HILL EAST PARCELS B1 + B2

WASHINGTON, DC
GTM ARCHITECTS DC PROJECT #21.0515

B2 ELEVATION - PRIVATE DRIVE | A3.03

APPROVED
ZONING COMMISSION
District of Columbia
CASE NO. 24-008
SUBMIT NO. 2A7

B2 ELEVATION - PRIVATE DRIVE | A3.03

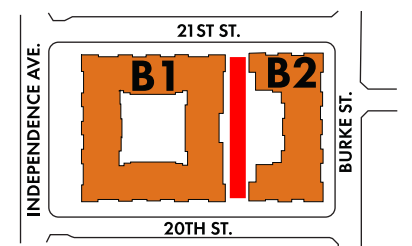
AREA OF MODIFICATION

NOTE: DELETION OF RETAIL

AREA OF MODIFICATION

NOTE: SIMPLIFIED
MECHANICAL PLATFORM
WITH DELETION OF RETAIL

AREA OF MODIFICATION

NOTE: BUILDING HEIGHT REDUCED
DUE TO DELETION OF RETAIL

B2 21ST STREET ELEVATION

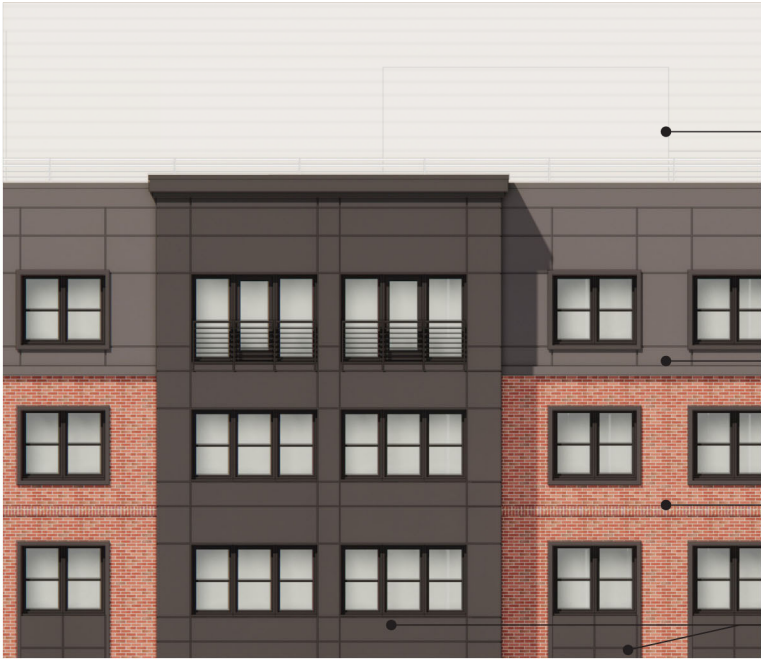
AREA OF MODIFICATION

NOTE: TRANSOM WINDOWS ADDED.

AREA OF MODIFICATION

NOTE: MATERIAL CHANGED FROM CEMENTITIOUS PANEL TO BRICK.

AREA OF MODIFICATION

AREA OF MODIFICATION

NOTE: DELETION OF RETAIL
